Kensington Gold Project

FINAL ENVIRONMENTAL IMPACT STATEMENT

VOLUME II APPENDICES

Kensington FEIS Index to DEIS Written Comments & Responses

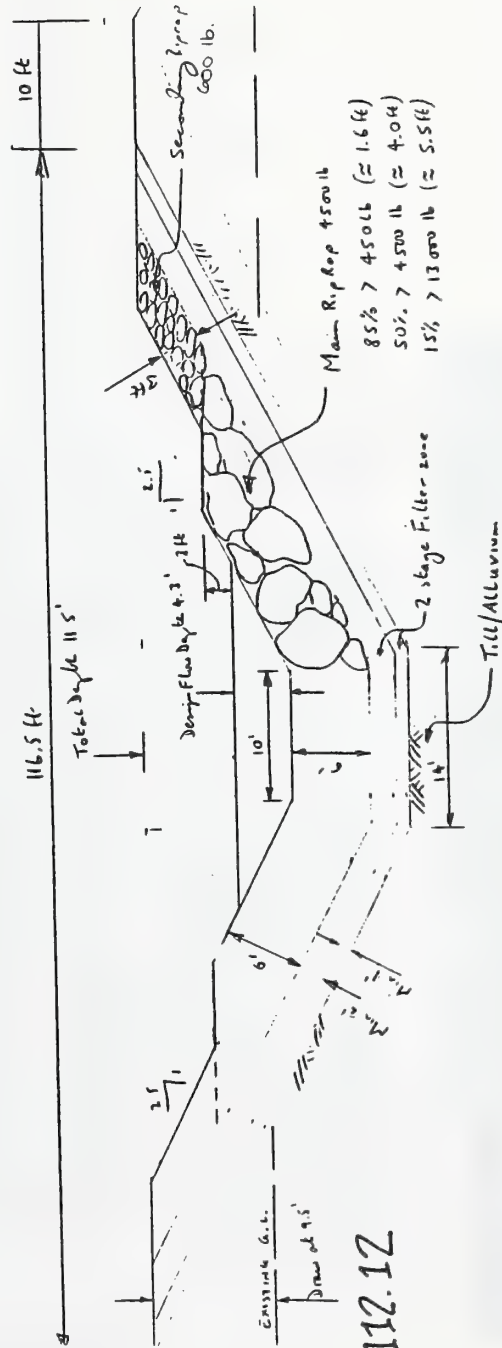
Assuming that the 4 feet diameter is satisfactory, a typical section was drawn up and is attached as Figure 1. The design consists of a main channel section with rip rap designed to resist velocities up to 22 ft/s. A freeboard of 2 feet is provided, above which a further 5 feet of secondary rip rap is provided (up to the energy depth) to accommodate splash. Below the rip rap there is a filter zone, which will require at least two stages and be 3 feet thick minimum, dependent on the filter relationship required.

Comet Port & Helicopter Facility Vs Berners Bay Shuttle Ferry
& Existing Road, Tunnel

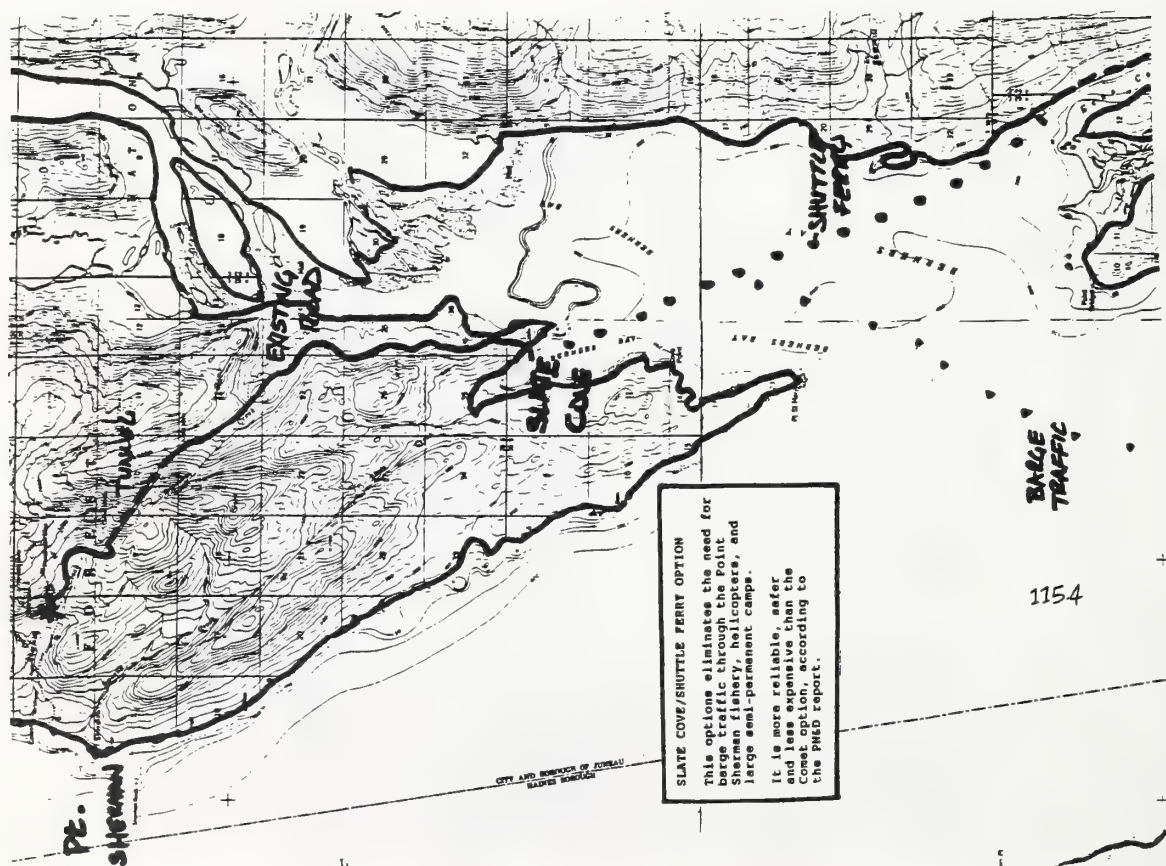
Quoting from PN&D report, "Figure 9 summarizes the net present worth of the five alternatives under consideration. On the basis of economic criteria, Alternative 5 (daily shuttle ferry between Echo Cove and Slate Creek Cove) is clearly superior at any discount rate considered.

Figure 3-26. Bald Eagle Nest Sites

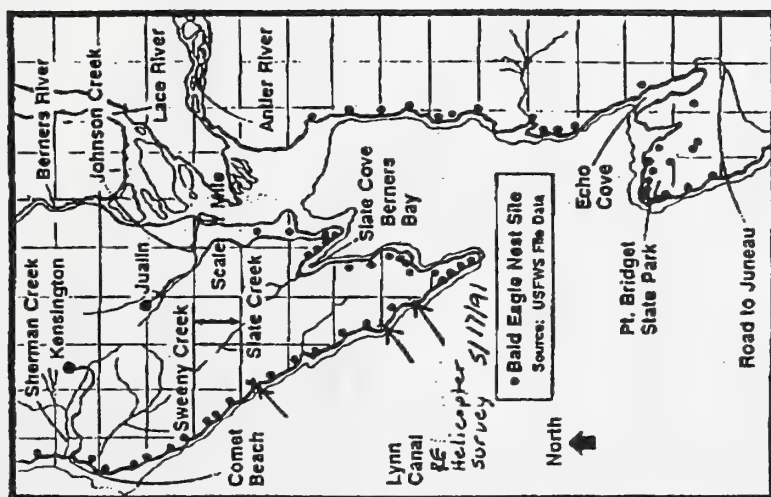
Page 3-45, column 1, Figure 3-26 should be updated in the EIS to include three additional bald eagle nests as shown on the attached Figure 1.

Three new bald eagle nests to be included on the Figure 3-26 on Page 3-45.
